M E M O R A N D U M

TO: Douglas Smith, P.E., Acting Chief, Engineering Review
Section, Bureau of Sewers

FROM: Gordon Yee, P.E., Acting Chief, Private Drainage Review
Section, Bureau of Sewers

SUBJECT: Hydraulic review of Amtrak-West Side Connection, West 37th
Street to Harlem River, Borough of Manhattan

LOCATION #3

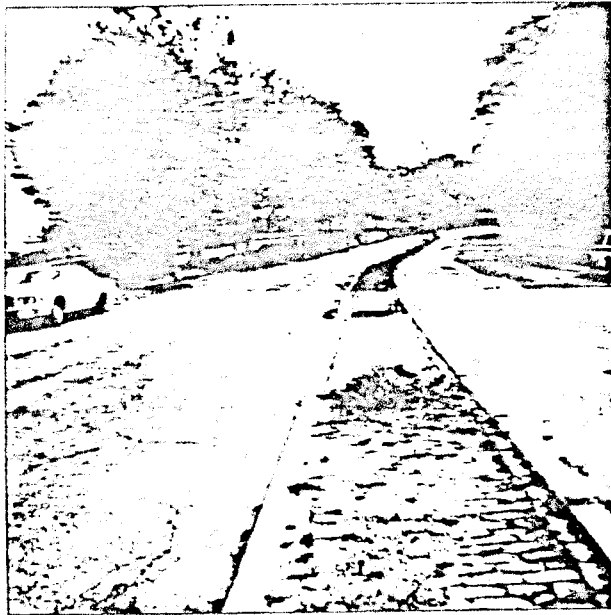
3) Riverside Drive between West 139th Street and 140th Street

There are low points on Riverside Drive that accumulate runoffs during rainstorms. This accumulation runs down into the Amtrak Area.

a) The west curb line reveal on Riverside Drive between West 139th Street and West 140th Street is 1". (Standard curb line 6").

b) The section Map #2119 from Topographical Bureau on Riverside Drive between west 139th Street and West 140th Street shows good pitch for runoff. (See attached sketch).

It is recommended that a Highway Capital Project be prepared to bring the street pavement to its legal grade so that a rain water will enter the catch basins and ponding will be eliminated.

SKETCH OF PROBLEM AREA:

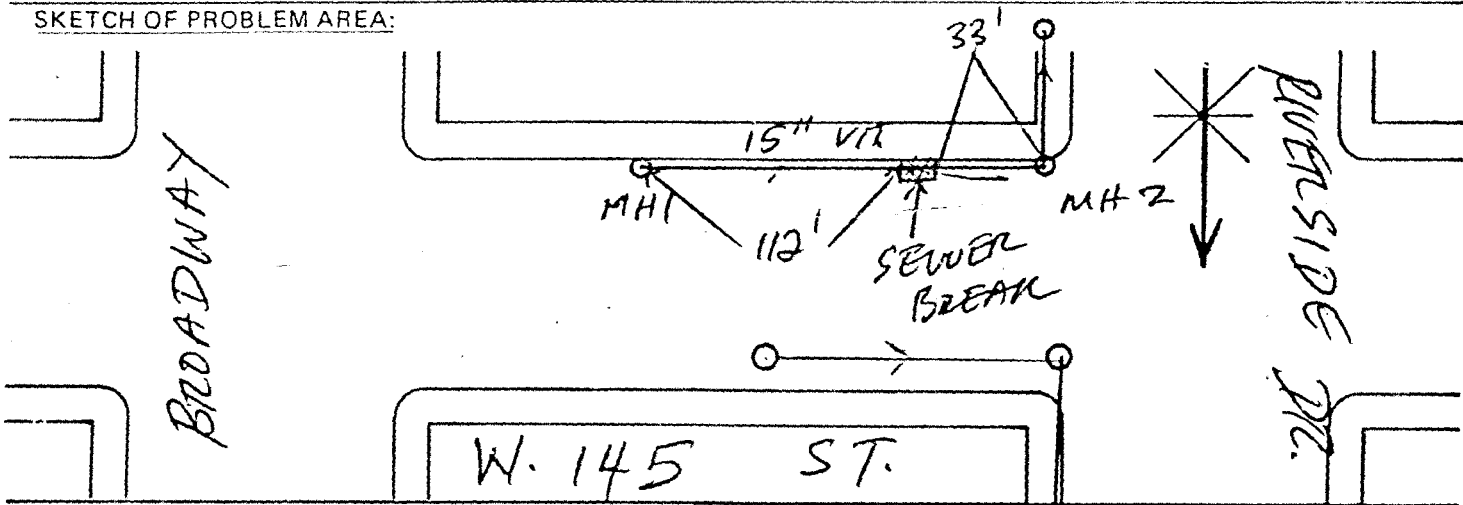
SEWAGE LEAK ON AMTRAK.
DYE TEST REVEALED A LEAK AT 112' FROM
M.H. 1 AND 33' FROM M.H. 2. REPAIR REQUESTED

W. 147 ST.

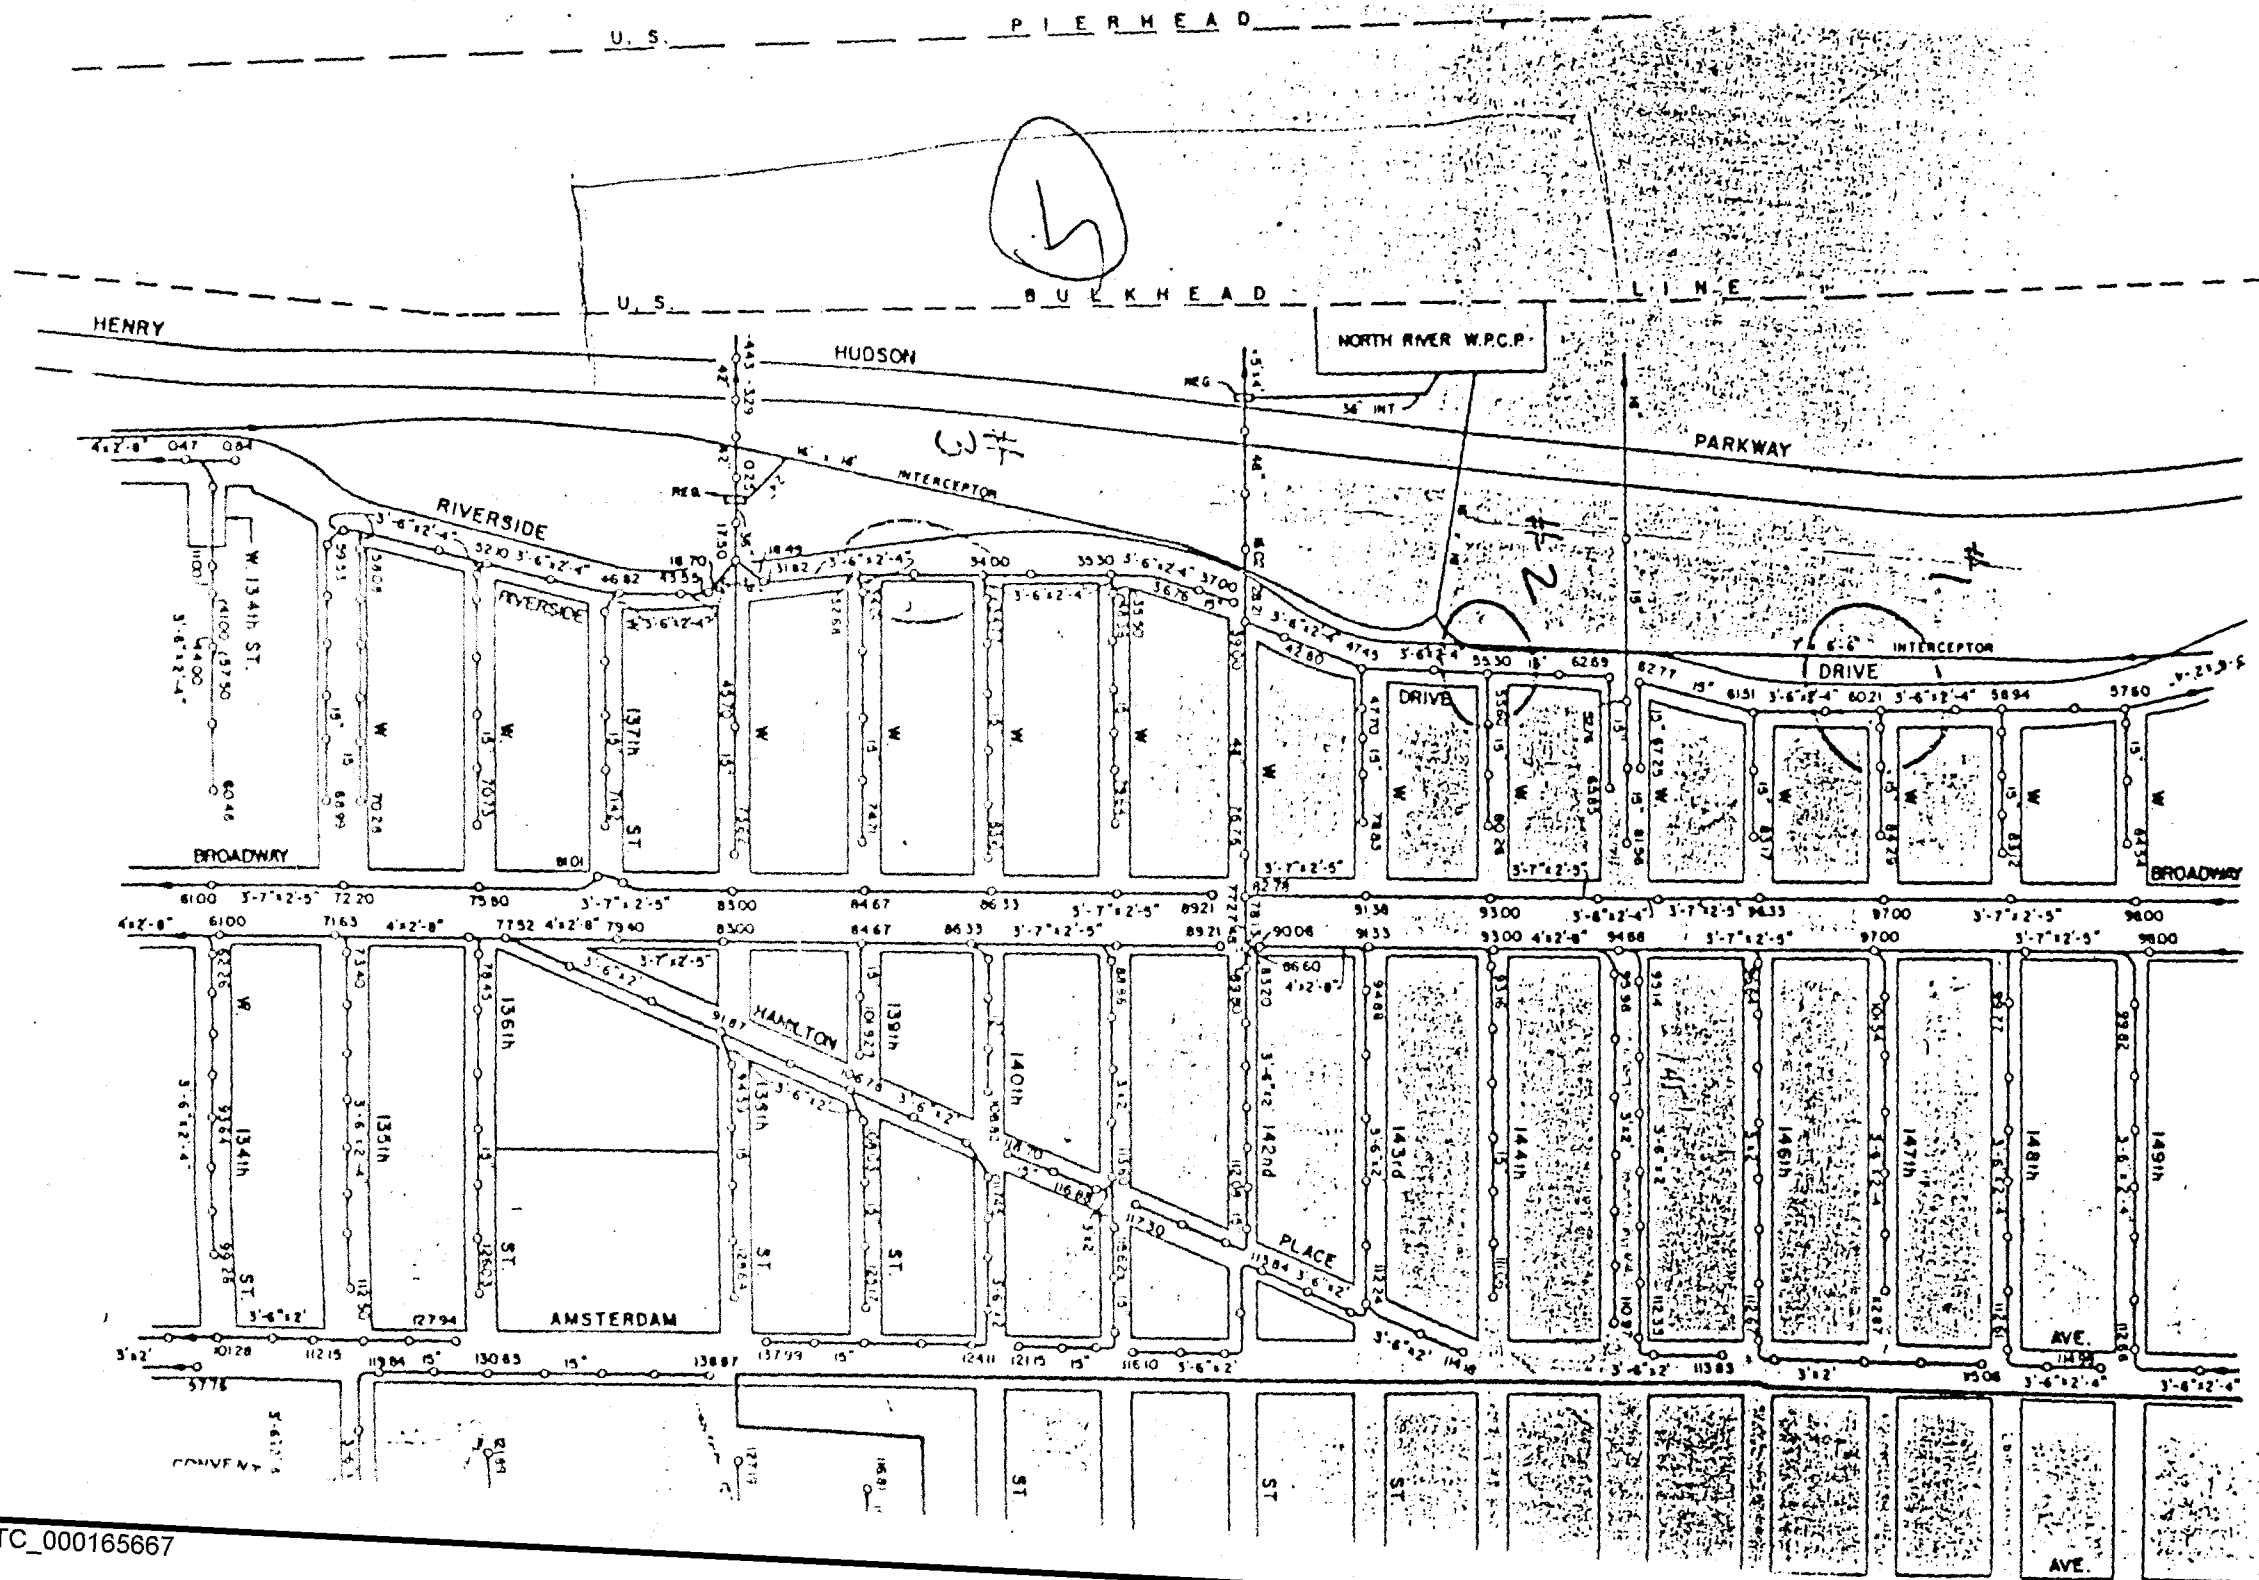
1) On Riverside Drive and West 147th Street

A leak was observed on the track. Dye tests and T.V. Inspections reveal that the 15" combined sewer at West 147th Street is not connected to the 3'-6"x2'-4" sewer on Riverside Drive as shown in North River drainage area analysis.

The 15" sewer is 4 feet lower than the 3'-6"x2'-4" brick sewer. The 15" sewer would normally go to the river but is now collapsed and the sewage exits through the broken manhole west of Riverside Drive onto the Amtrak Railroad. It is recommended that the 15" combined sewer at West 147th Street and Riverside Drive be connected to the 3'-6"x2'-4" brick sewer under capital project. We will perform trap elevation survey in preparation for the capital project to connect the 15" sewer to the 3'-6"x2'-4" brick sewer.

DEFECTIVE
DROPWELL
MANHOLE

TO BE CONNECTED TO THE
3'6" x 2'4" BRICK UNDER
CAPITAL PROJECT.
